Addendum No. 03

File Reference Number: RFP 2026 053

Title: Design-Build of New North Bay Shops Building

RE: Clarifications/Questions

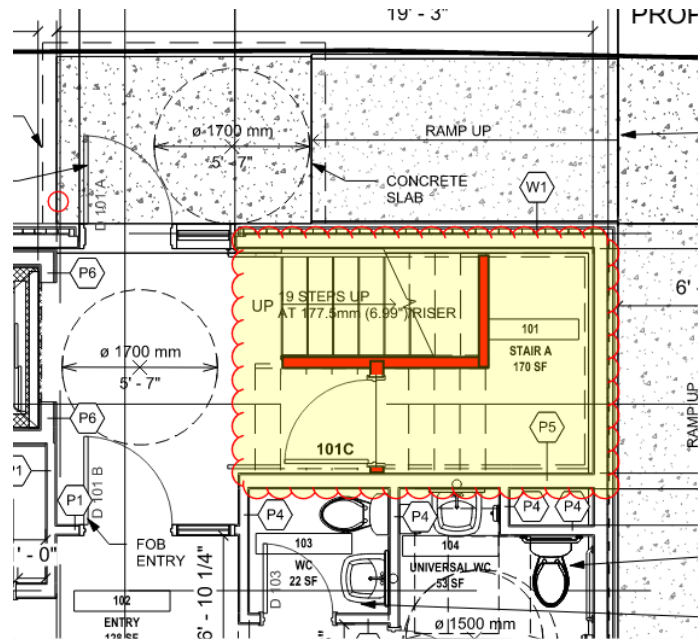
- Refer to the Preliminary Design Brief previously issued for Cost Estimating on August 24, 2026. Replace the mechanical and electrical portions of that Preliminary Design Brief in their entirety with the revised mechanical and electrical design information dated September 21, 2026, issued with this Addendum.
- Refer to the Main Floor Plan. Close off access to the area below the stairs at Stair A using a P4 partition and a 36-inch rated hollow metal door and frame complete with storeroom lockset and closer. Recess the door to accommodate the door swing and apply rated drywall to the underside of the stairs and landing, as shown in the consultant's issued illustration.
